ADDENDUM NUMBER 3 ON INVITATION TO BID ITB21KO-102

TITLE: Exterior Doors Replacement at Whitney Lab Building 1012

List of Doors to be replaced:

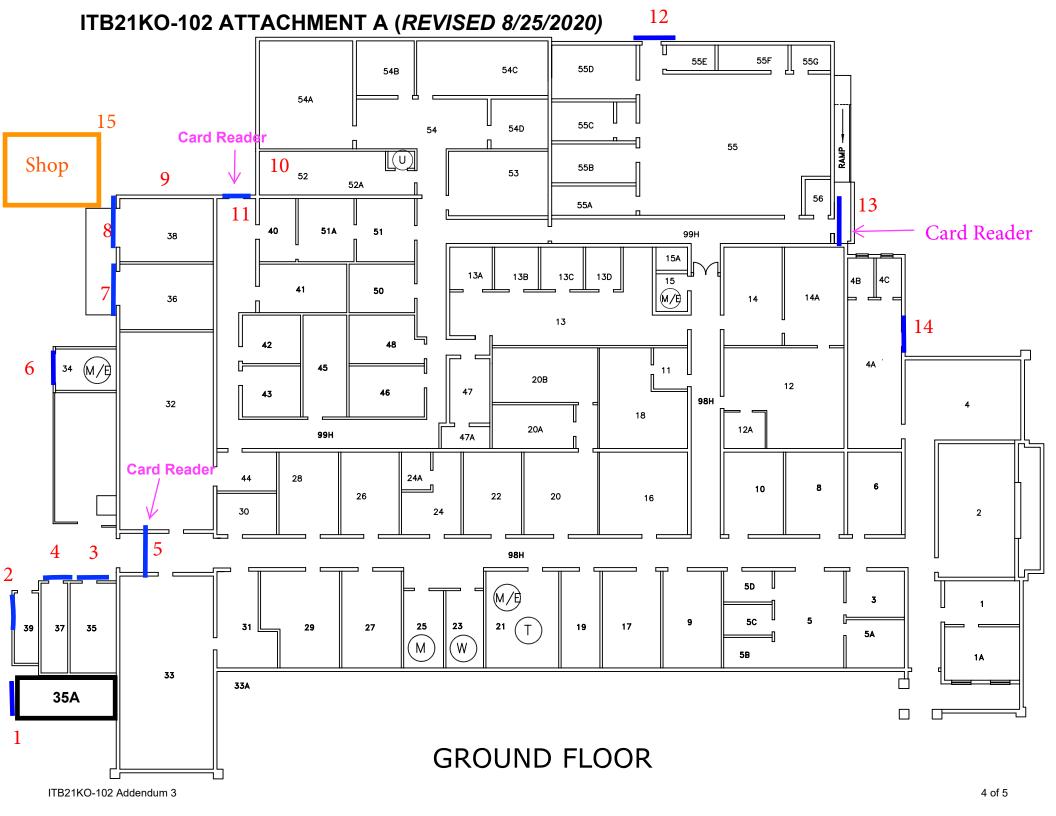
Scope of Work: This ITB is for the replacement of 13 steel exterior doors at Whitney Lab Building #1012, 9505 Oceanside Blvd. St Augustine, Florida. All doors are to be replaced with doors manufactured of new impact rated fiberglass, commercial quality design. This ITB consists of a Base Bid for for new vendor provided doors, frames, all hardware, installation and UF permit fees and demolition of current doors and frames.

- See Attachment A for door locations.
- See Attachment B list of doors.
